AMENDMENTS TO THE DRAWINGS

Attached hereto are three sheets of annotated drawings showing proposed amendments to the Figures. The annotated sheets incorporate the following proposed changes:

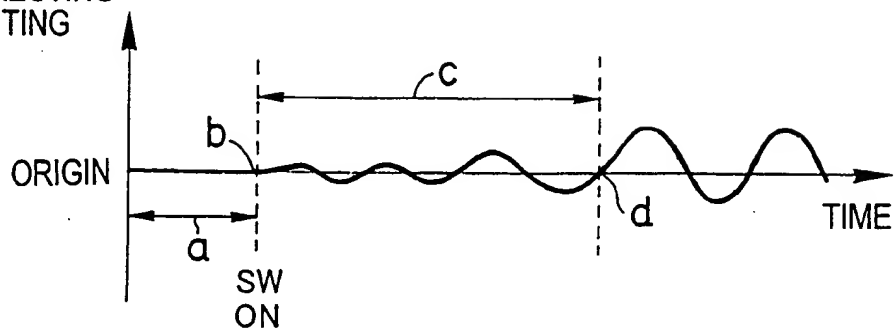
- Figure 7 has been modified to read "SW ON" from "SW OFF" to enhance consistency with the specification. See e.g., *Specification, page 10, lines 10-11.*
- Figure 9 has been modified to read "SW OFF" from "SW ON" to enhance consistency with the specification. See e.g., *page 20, lines 4-6.*
- Figure 11 has been modified to change the label "20" to "120". See e.g., *page 21, lines 2-4.*
